ADDENDUM # 1

DATE: April 11, 2025

**FOR: PCDL – NEW LEXINGTON
ADDITION & RENOVATION**

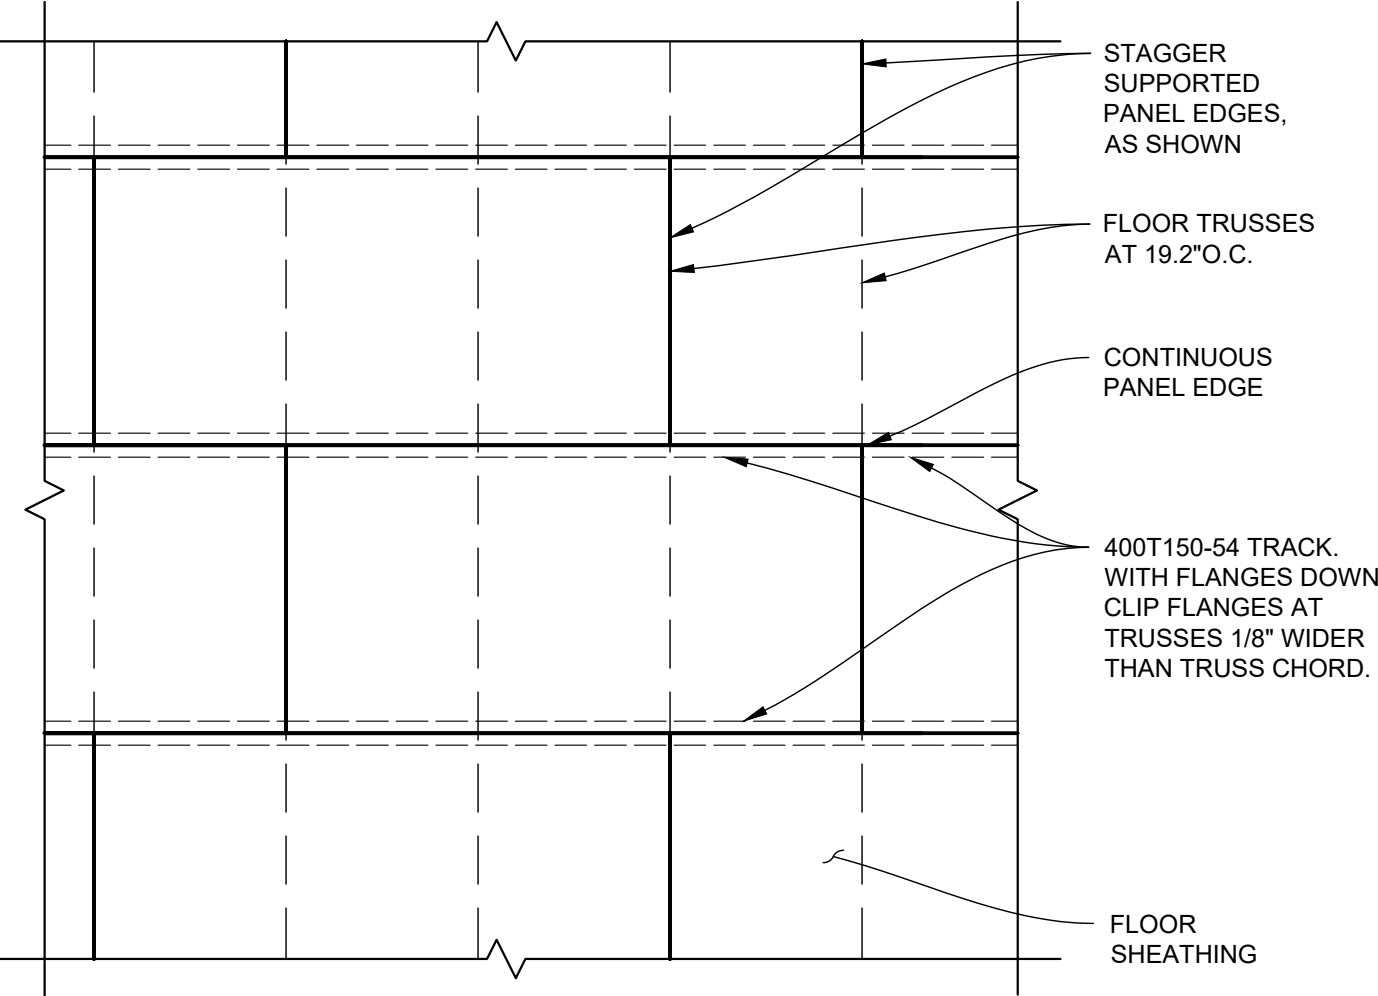
Item #1 Floor Framing Plan – replace S2.1 with attached

- a. Revised plan notes
- b. Added keynote #16 & #17

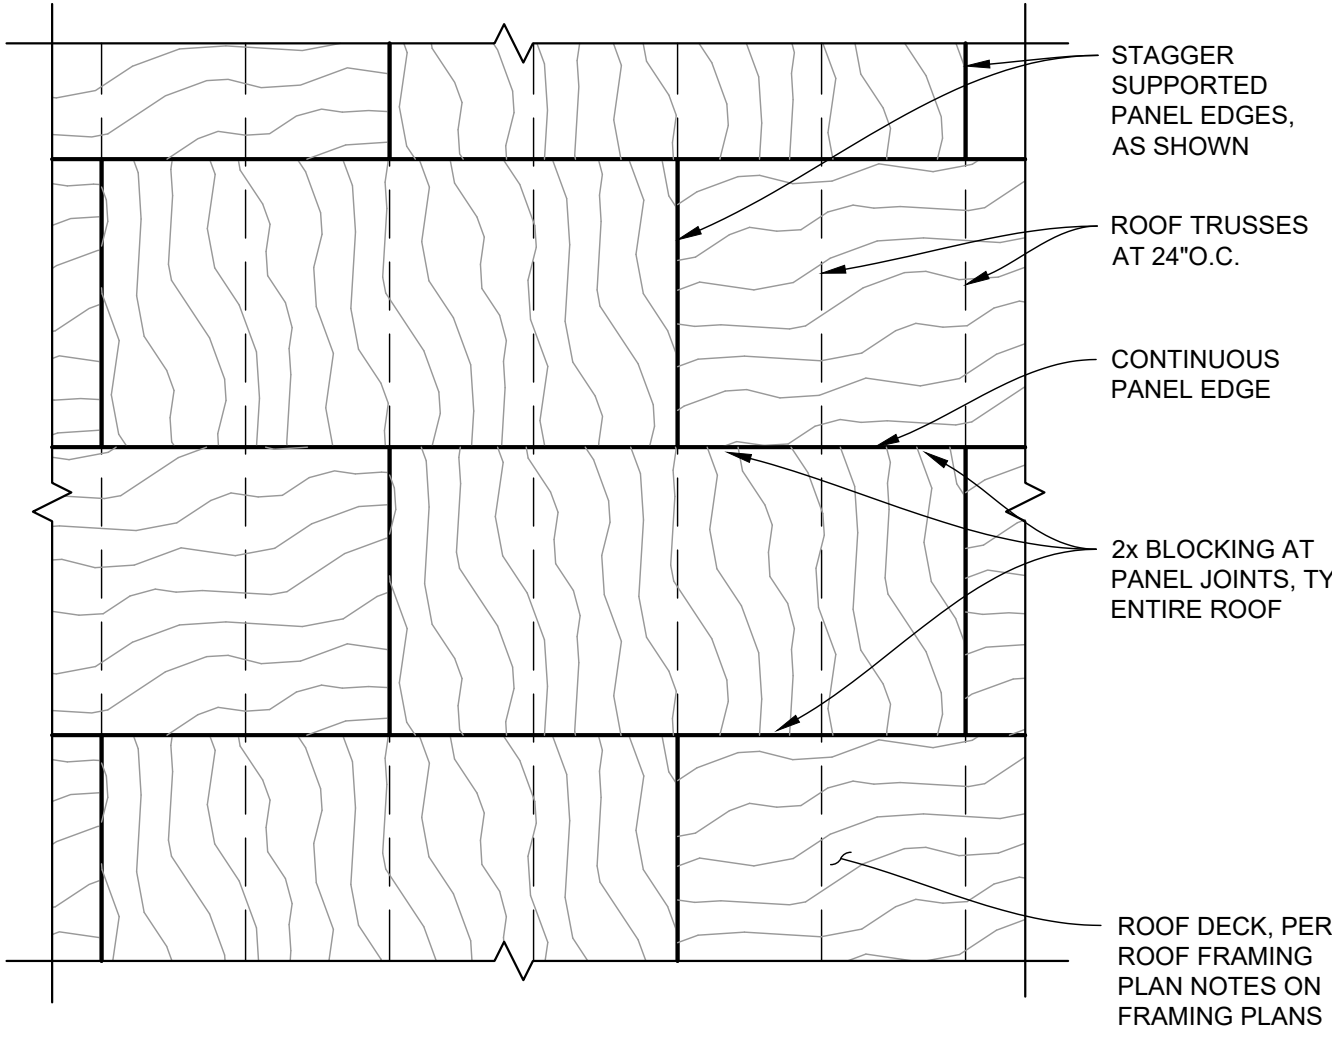
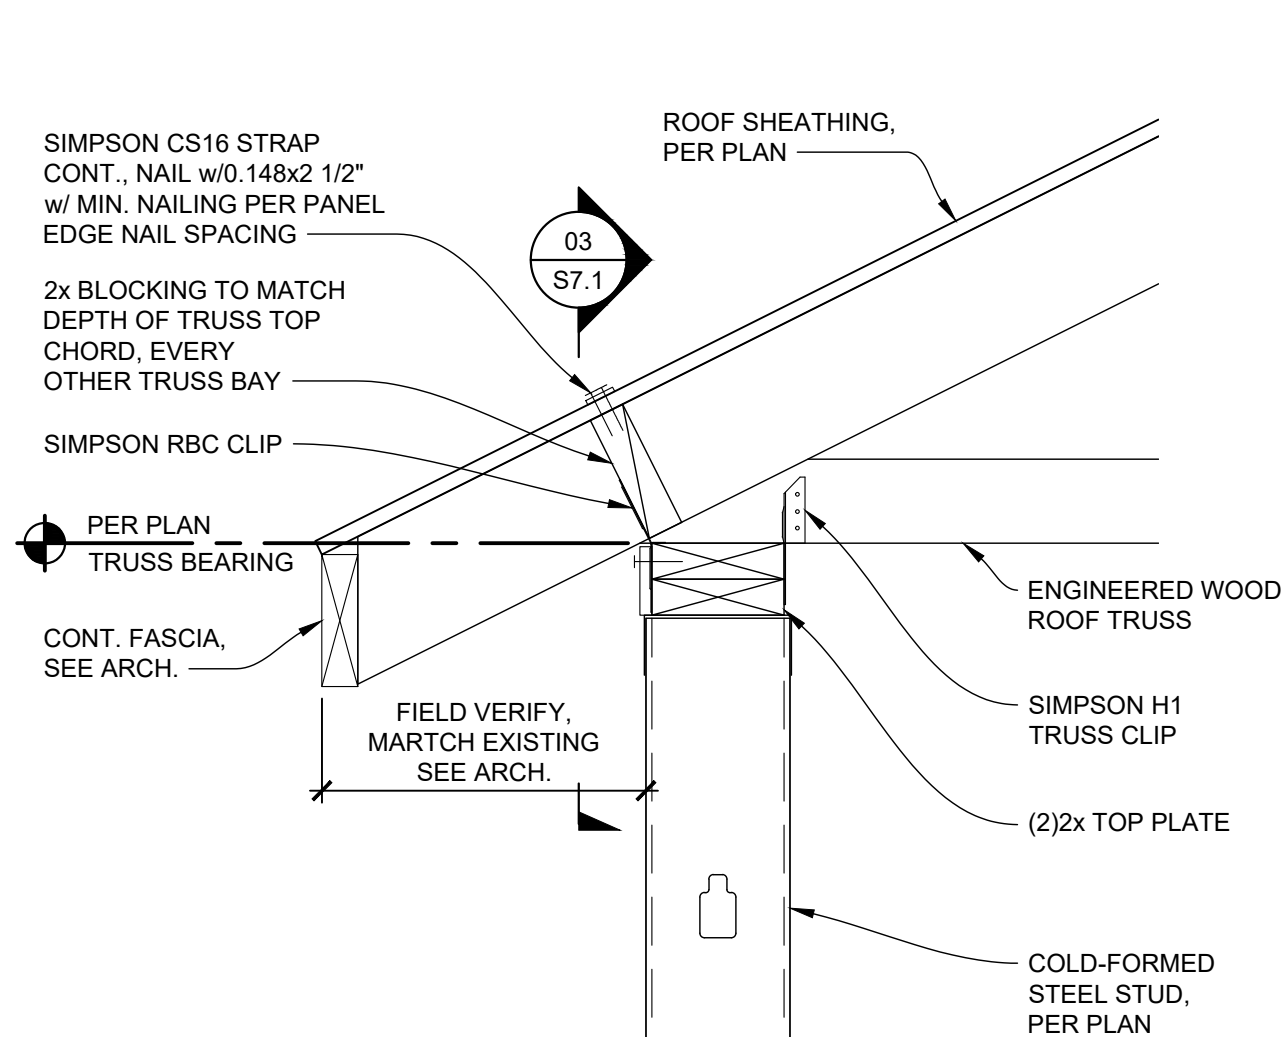
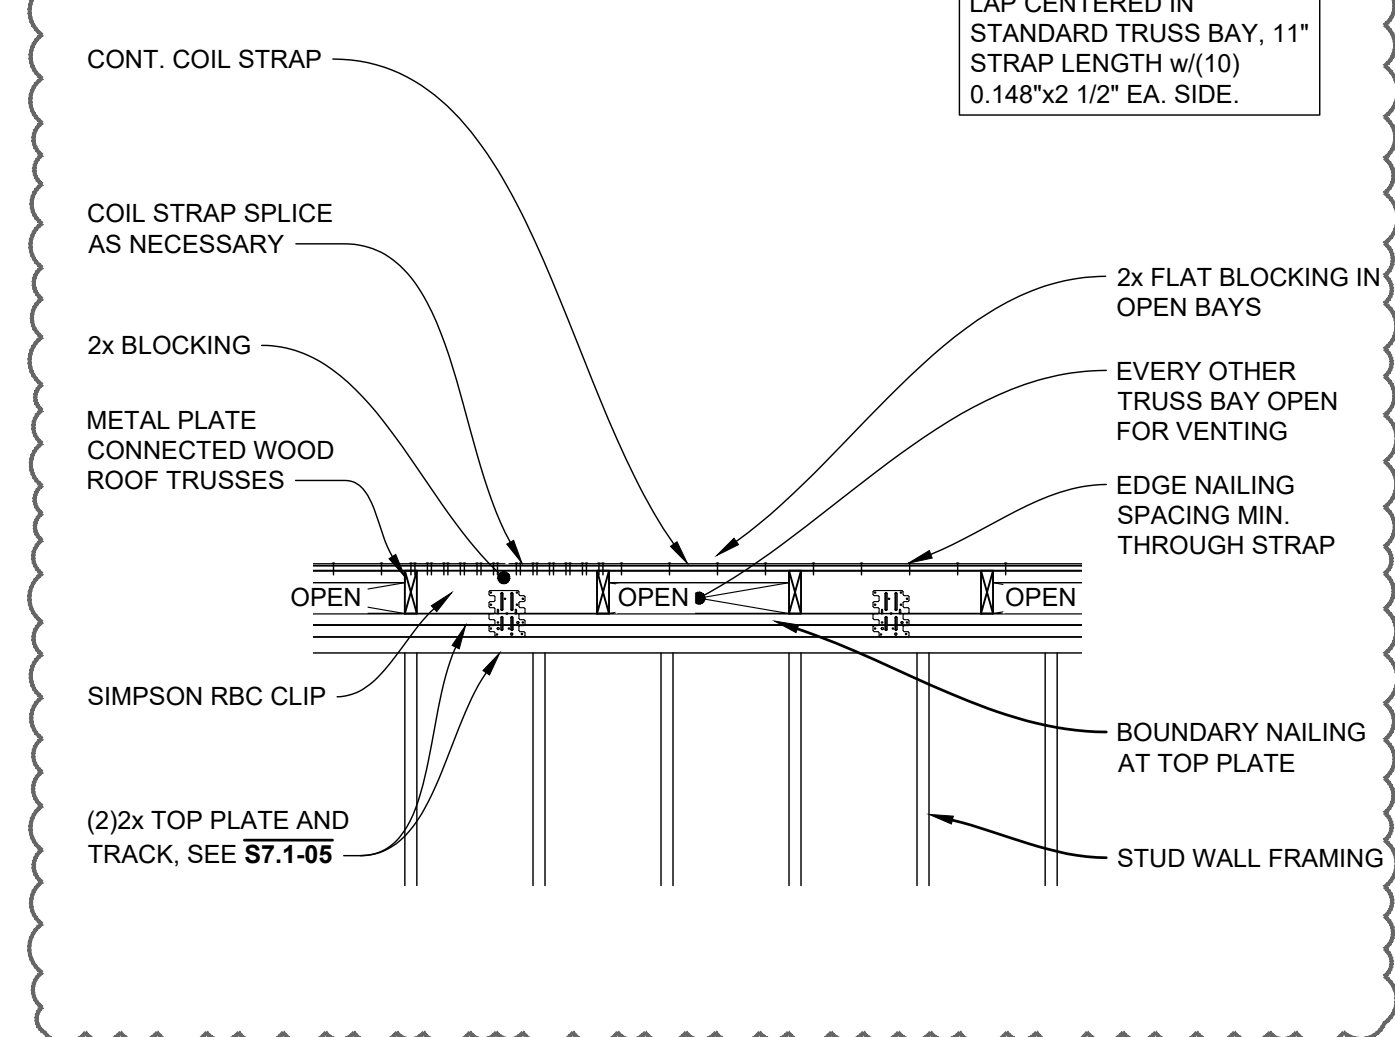
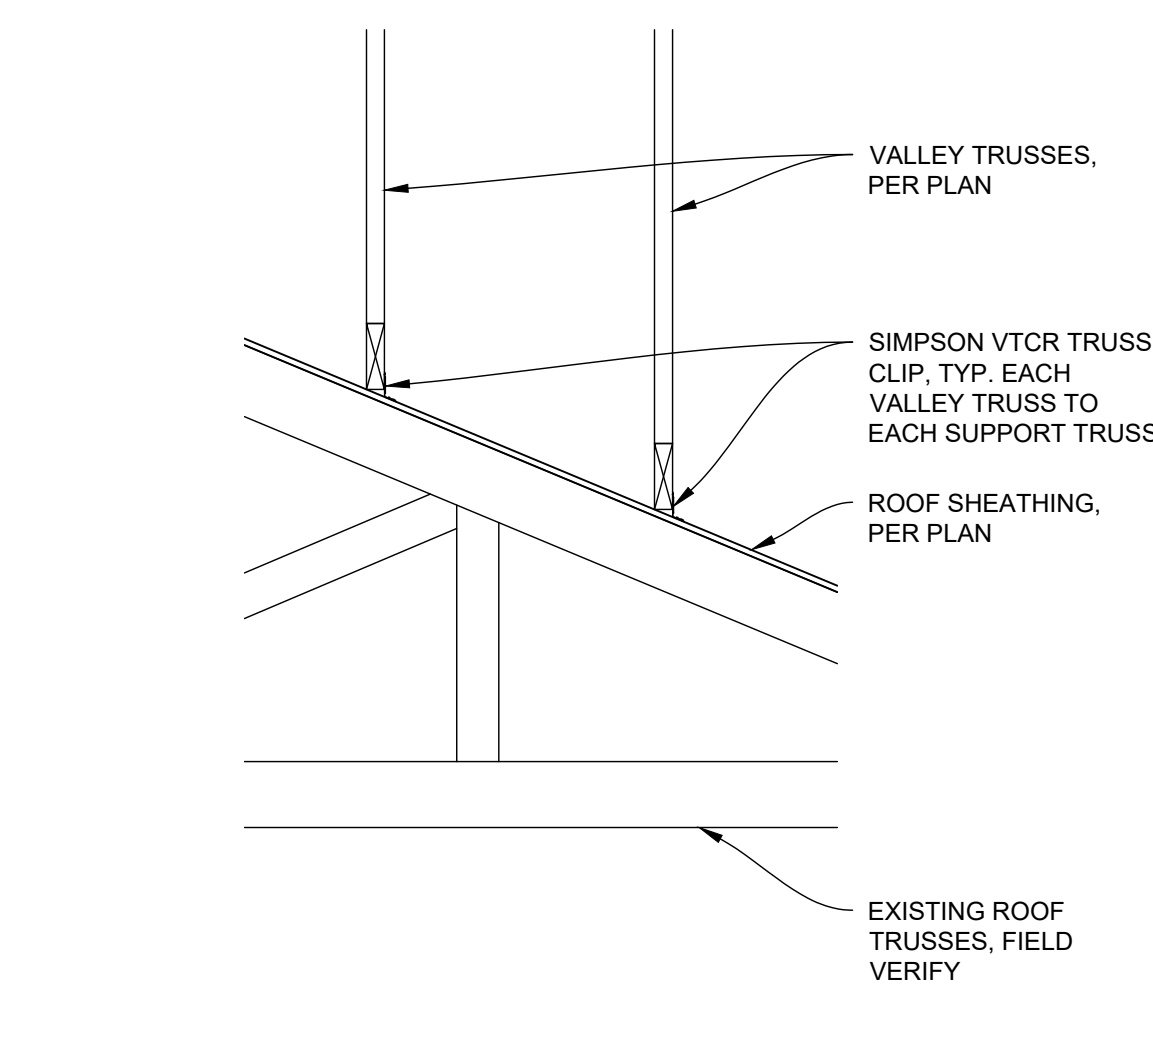
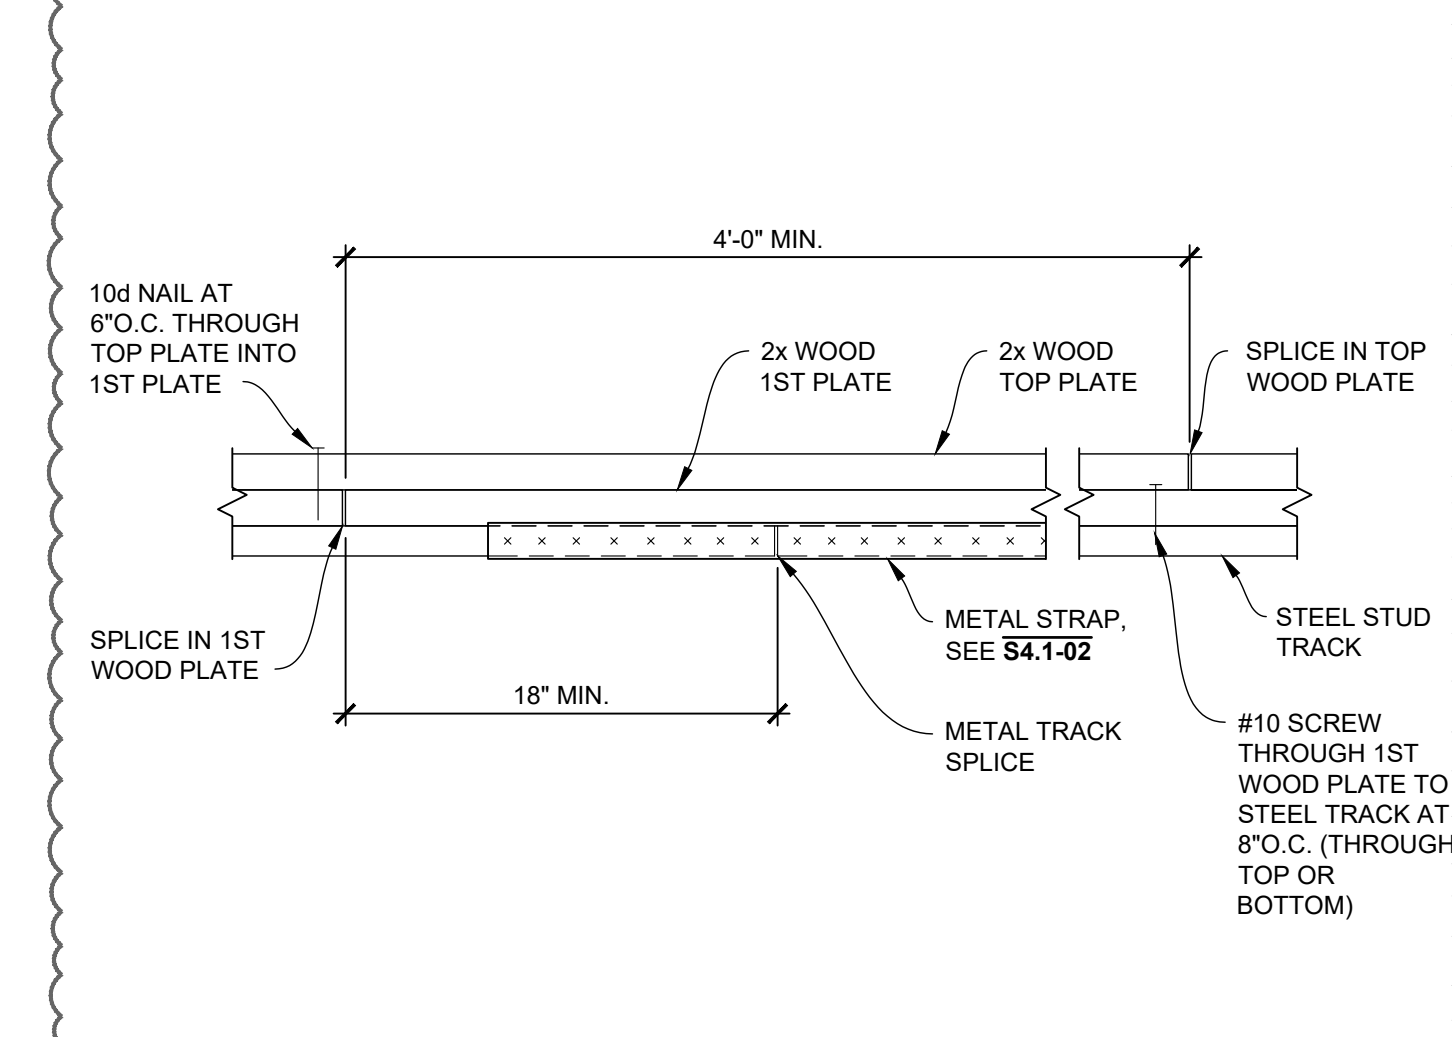
Item #3 Roof Framing Details – replace S7.1 with attached

- a. Revised detail #03
- b. Added new detail #05 (“Wall Top Wood Stud Plate Splice”)
